**URGENT FIELD SAFETY NOTICE
MEDICAL DEVICE CORRECTION**

MAQUET CARDIOSAVE hybrid and MAQUET CARDIOSAVE rescue

Product Code/Part Number:	0998-XX-0800-XX
Distributed Affected Lot Number:	All
Distribution Dates:	Since March 6, 2012

Figure 1 – Monitor Display (1 – Helium Indicator)

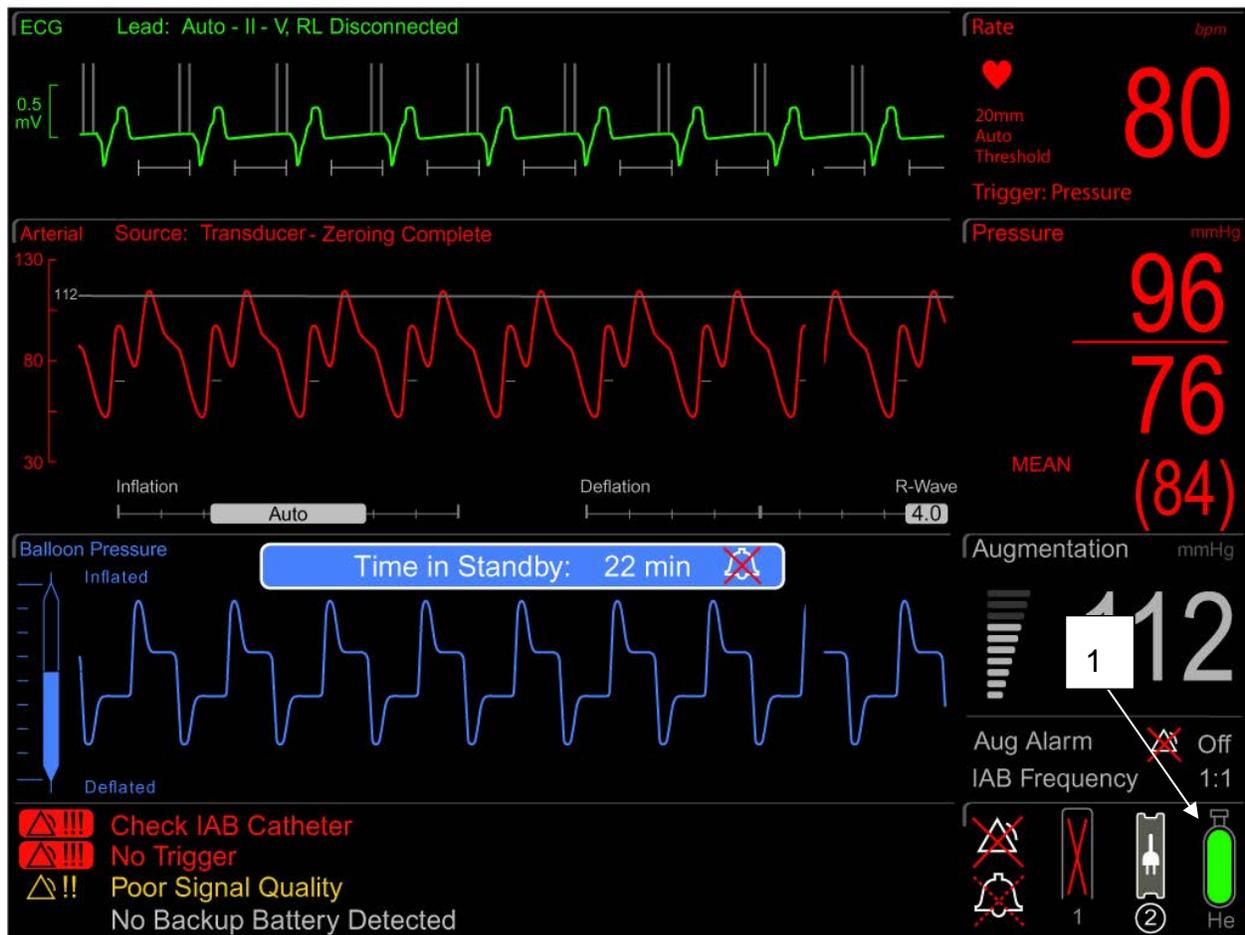
During Electromagnetic Compatibility (EMC) testing at an external lab, Getinge personnel determined that in the presence of some radiated RF disturbances, the Helium Indicator on the Cardiosave IABP (refer to Figure 1) would intermittently over-report the remaining Helium Capacity. Once the disturbance was removed the Helium indicator always fully recovered within 10 seconds to display the proper level without any over-reporting.

Getinge’s investigation revealed that the over-reporting of Helium Capacity would intermittently occur at frequency ranges between 80 MHz – 1 GHz. Potential sources of interference include: radio communication, cell phone, Wi Fi, RFID equipment and equipment that does not meet current electromagnetic compatibility standards.

Datascope/Getinge is developing a hardware correction to address this issue. A Datascope/Getinge service representative will contact you to schedule the installation of the correction when available. This work will be done at no cost to your facility.

Figure 2 – Top Panel (1 – Mechanical Helium Gauge)

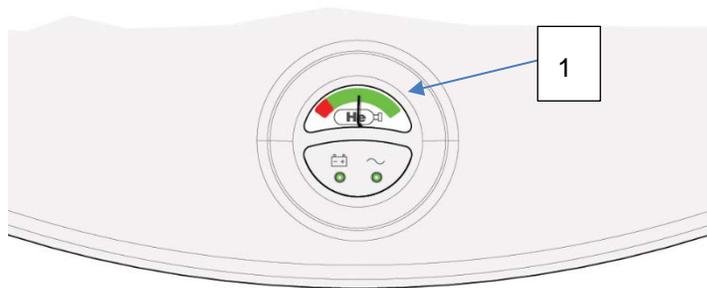
Since the mechanical gauge is not influenced by EMC, view the mechanical gauge on the Cardiosave Top Panel (See figure 2) to assess remaining helium capacity in case of suspected EMC disturbances.
